**Western States Petroleum Association**  
Credible Solutions • Responsive Service • Since 1907

May 29, 2015

**Subject: Comments on the State Water Resources Control Board's Draft Model Criteria for Groundwater Monitoring in Areas of Oil and Gas Well Stimulation**

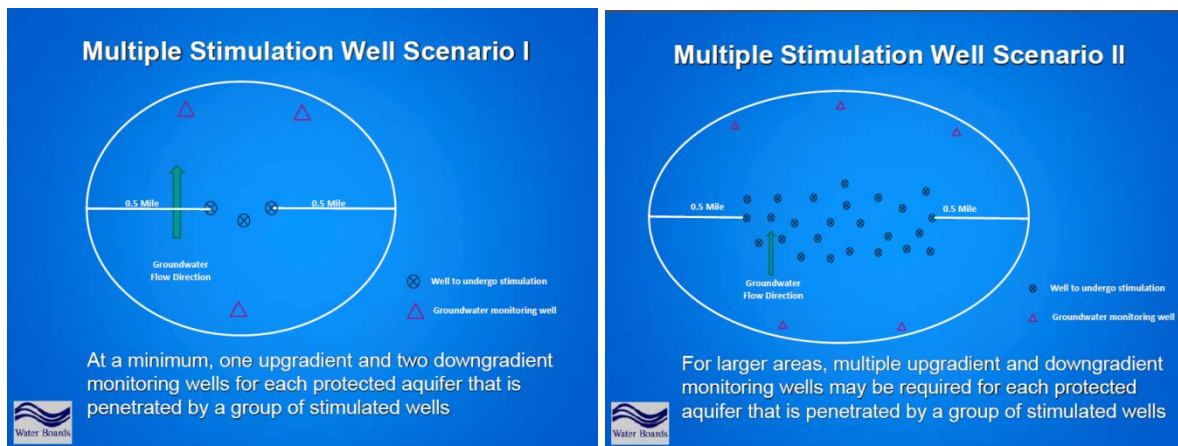
At the public workshop on May 19, 2015, Board staff delivered a presentation including the two slides below (Slides 18 and 19). Based on the slides below, WSPA’s understanding is that the Board is viewing a group of wells, together, as forming the boundary for which the area-specific monitoring plan criteria (e.g., placing monitoring wells at 0.5 miles of the ADSA) is to be applied.

WSPA recommends the following changes to the draft Model Criteria text in Parts 1 and 2 on page 5 to address these concerns (text changes as underline/strikeout):

1. *At a minimum, one upgradient and two downgradient monitoring wells will be required for each ~~protected aquifer that is penetrated by the~~ stimulated well, or group of stimulated wells. ~~Upgradient~~Downgradient groundwater monitoring wells shall be located within 0.5 mile of the surface projection of the well ADSA or the perimeter of a group of wells being stimulated, provided permission to install and sample wells is granted by the landowner(s). The operator may propose an alternative number and locations of monitoring wells, provided that the proposed monitoring well or wells afford a similar or higher level of monitoring effectiveness relative to the minimum requirements.*
